CASE SUMMARY SHEET

CASE NUMBER: V23-06-19 DATE RECEIVED: April 27, 2023

REQUEST: V23-06-19 – Seven Oak Square, LLC requests a variance to CLURO Section 10.5.3.3. Free-Standing

REQUEST: V23-06-20 – John Keller requests a variance to CLURO Section 5.2.3.2. Drainage Overlay District and Fill

Monument Sign Details

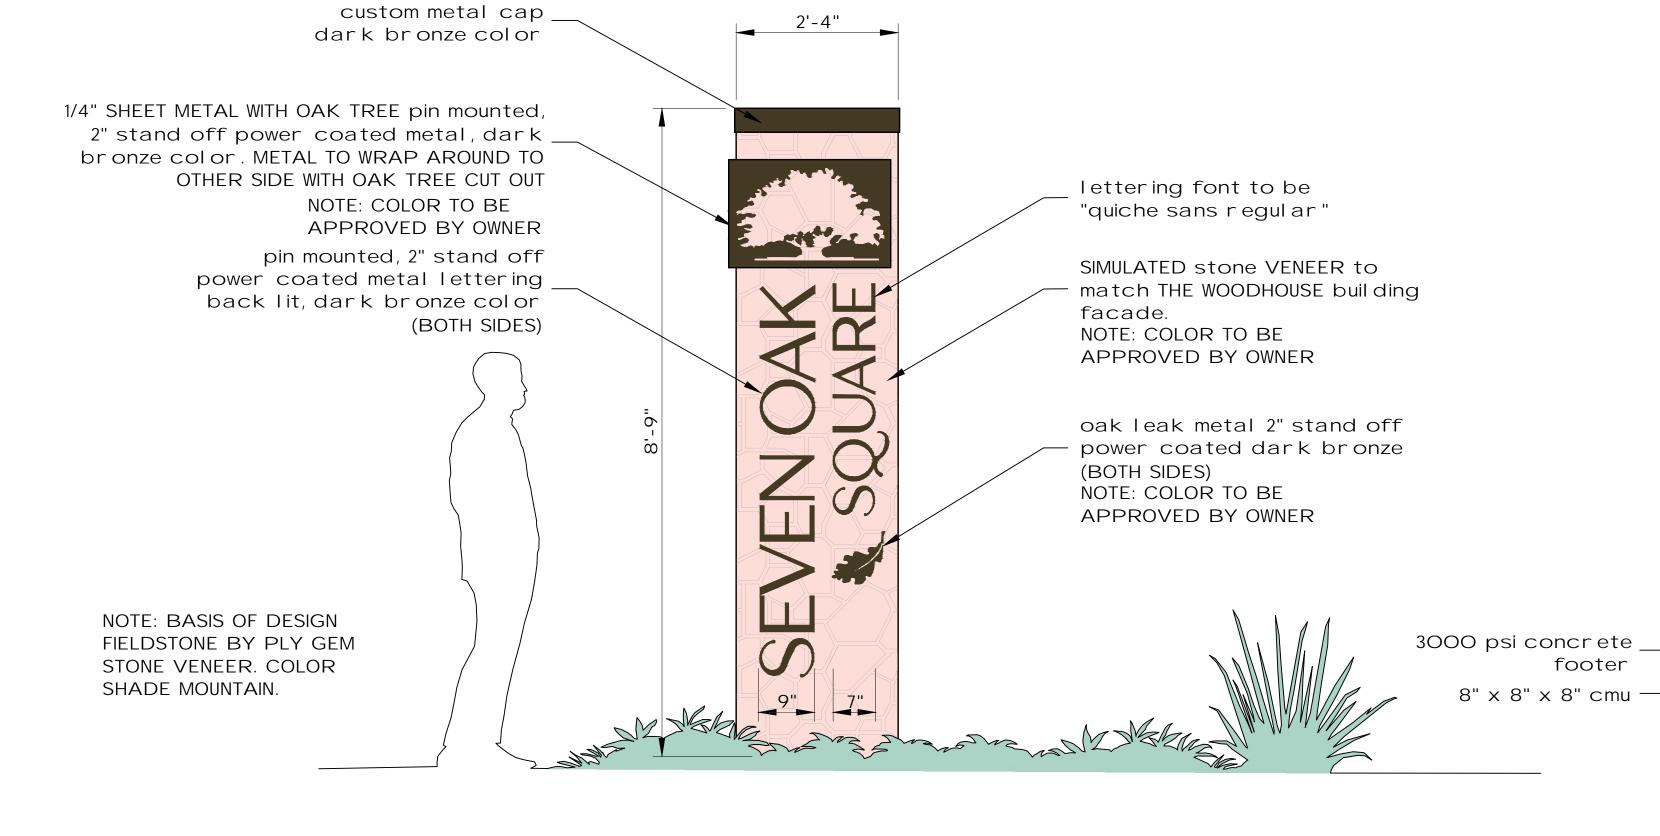
SIGN VARIANCE REQUESTED PER CODE 10.5.4.7

TO ALLOW THE SIGN HEIGHT TO BE INCREASED BY 25% OR BY 1'-9" (AS SHOWN)

FROM THE MAXIMUM SIGN HEIGHT OF 7' WITHIN THE B-2 ZONING CLASSIFICATION, THUS

ALLOWING THE MINIMUM HEIGHT FOR LETTERING OF 9" IN HEIGHT PER CODE 10.5.3.5
